**Safety Defect and Noncompliance Report Guide for Vehicles**  
**PART 573 Defect and Noncompliance Report<sup>1</sup>**

Furnish the manufacturer's identification code for this recall (if applicable): ITS-2271

# ITS: 2271

Shorten and re-orientate transmission cooler line.

**Figure 1. Correct Transmission Cooler Hose Orientation**

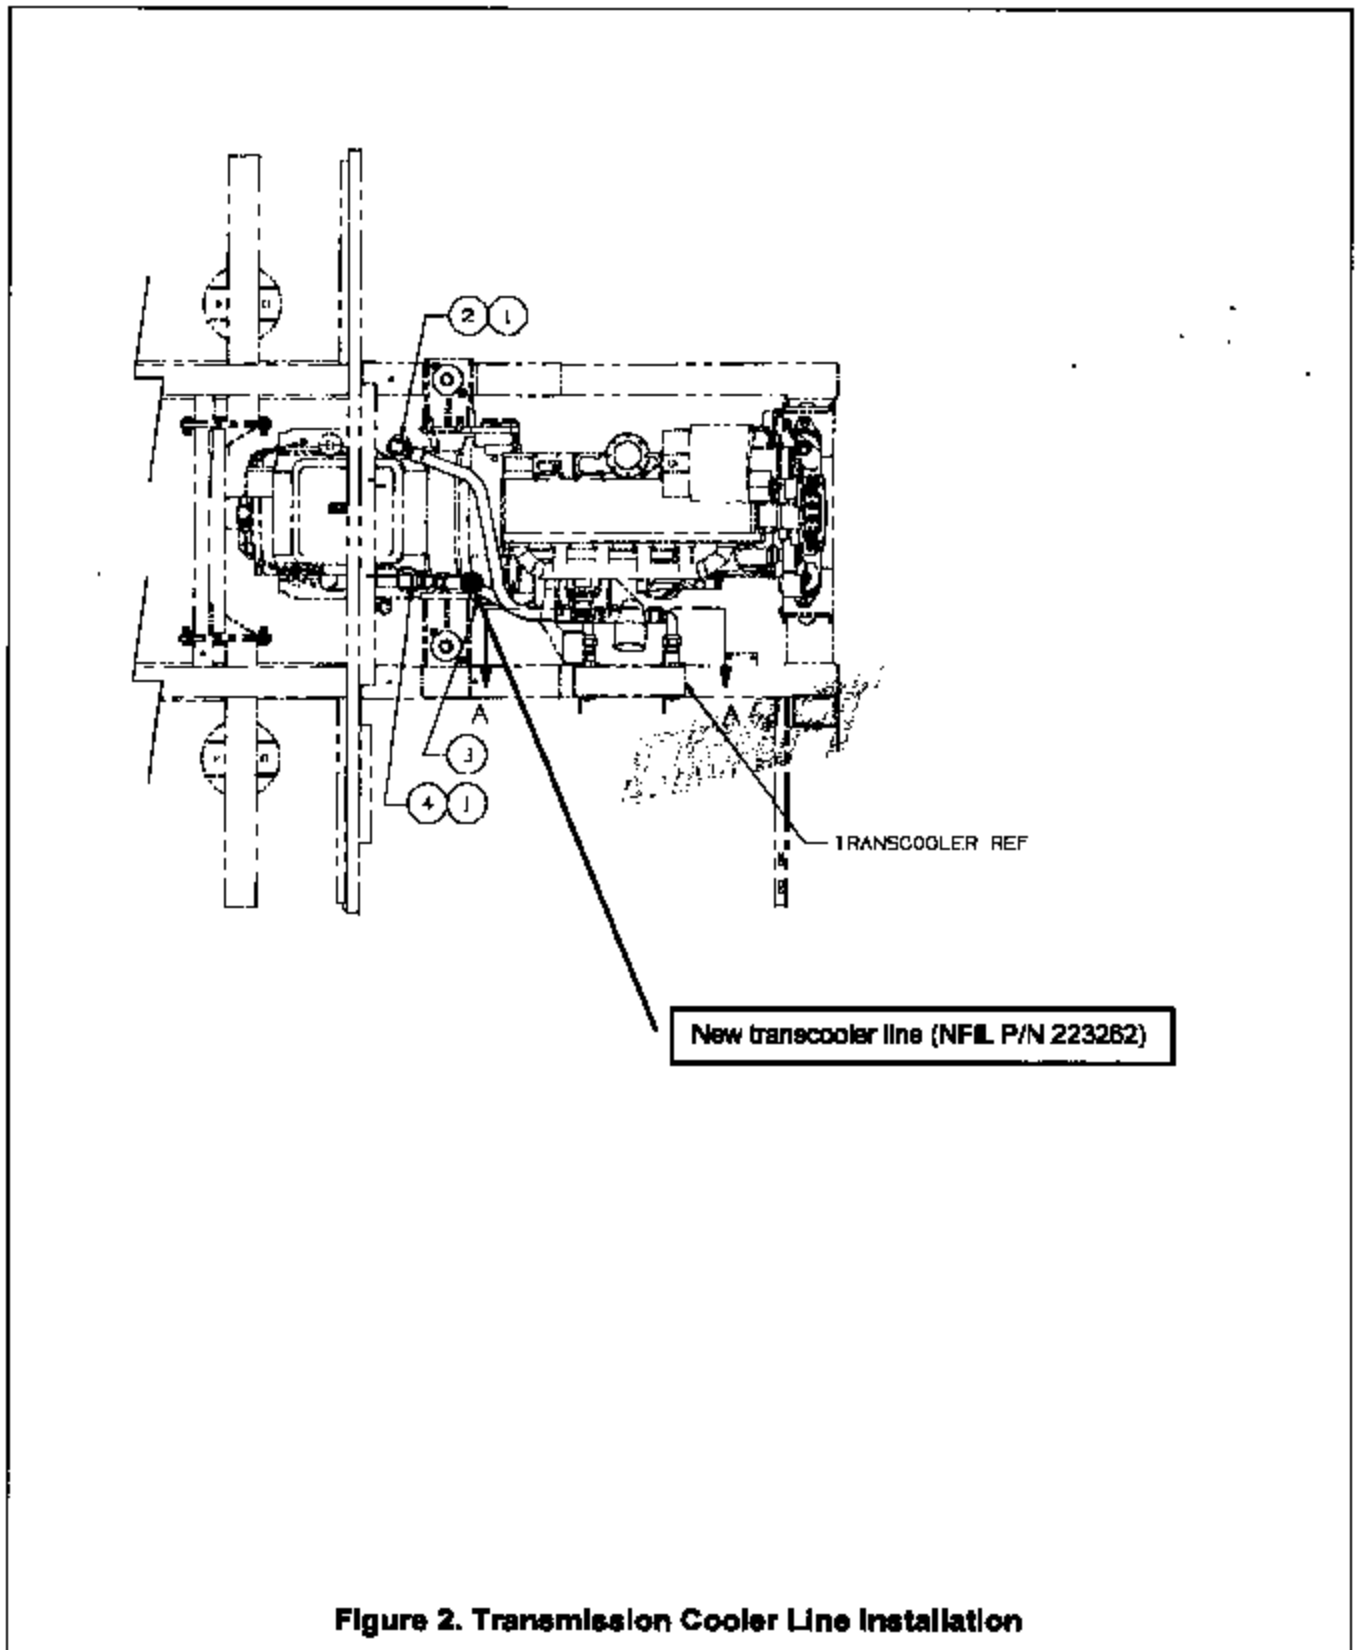
The transmission cooler line can rub on the auxiliary heater exhaust. This chafe point may lead to a premature failure of the transmission line and a subsequent transmission fluid leak may result. Transmission fluid, in the presence of a high heat source, can result in a vehicle fire.

4. Remove p-clips attached to roadside transmission cooler line.
5. Remove roadside transmission cooler line from transmission and transmission cooler (oil out side). **NOTE:** Be prepared to catch fluid with a container. Discard line.
6. Inspect auxiliary heater exhaust blanket. If hose leaking and transmission fluid has transgressed to blanket, then blanket replacement is necessary. Contact your Regional Product Support Manager to order replacement exhaust blanket.
7. Install 90-degree swivel adapter (NFIL P/N 022433) onto new transmission cooler line (NFIL P/N 223262) 45-degree fitting end. **NOTE:** Orientation must be so that 90-degree adapter spout will point to rear of coach and 45-degree fitting will direct hose upwards and 90-degree end of new hose points towards roadside for proper mating with transmission cooler. Refer

to Figure 1.

8. Install new transmission cooler line (NFIL P/N 223262) between transmission and transmission cooler. Orientate line so that 90-degree adapter is on transmission port. Refer to Figure 2.

Note: 90-degree adapter facing to rear of coach and 45-degree fitting directing new hose upwards.

Note: This end (90-degree) of the transmission cooler hose points to roadside of coach for mating with transmission cooler.

New Flyer has developed a different transmission cooler hose assembly installation that promotes additional clearance from the auxiliary heater exhaust system.

The new transmission cooler hose is slightly shorter than the existing transmission cooler hose, a 90 degree elbow has been added in addition to a slightly different hose configuration.

New Flyer is modifying the transmission cooler hose assembly and adding a fitting to the transmission port to promote additional clearance from the auxiliary heater exhaust system. The installation of the modified transmission fluid line is detailed in the attached Instruction to Service, ITS-2271. New Flyer will supply the parts and labor to replace the transmission hose.
